**REPAIR PRIMARY ELECTRICAL DISTRIBUTION SYSTEM- PHASE #7
SOLICITATION NND12418431E**

ANSWERS TO SUBMITTED QUESTIONS

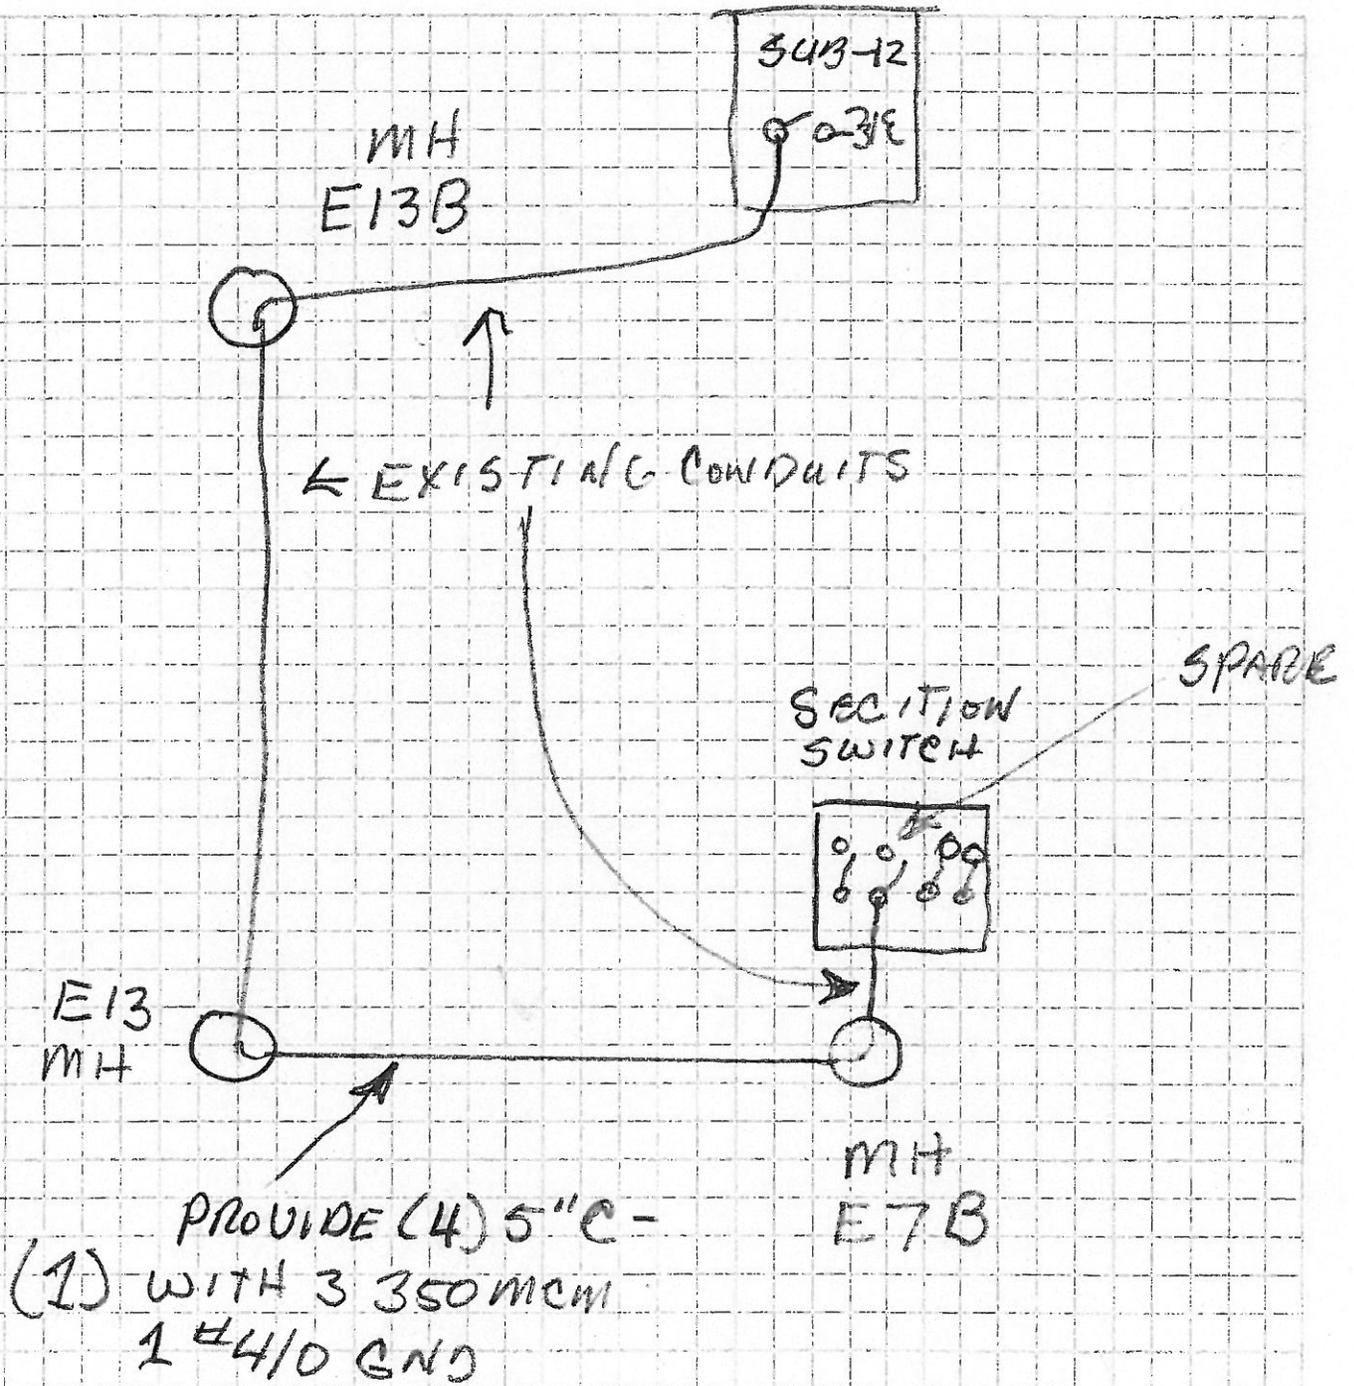
- 14A. Relocate to the new fence line.
- 15Q. Drawing E25 explains the new remodel work for Substation 12, but does not address what the existing conditions are. Please provide a post remodel single line for Substation 12 and the Sectionalizing switch. Also, which manhole is the t-tap shown on drawing E11, between Sub 12 and Sub 16, located?

- 15A. E-13B is where the "T" tap is located. (See attached Sketch)
- 16Q. Drawing E18 shows removing the concrete pads that all of the existing equipment sits on. Do the guard posts that surround the existing equipment get removed as well? Are the voids that are left from the removal of the pads, and if required the guard posts, to be replaced to match the surrounding asphalt paving?

PROVIDE NEW 3 350 MCM 1 #4/0 GND FROM SUBSTATION 12 TERMINATIONS TO THE EXISTING SECTION SWITCH
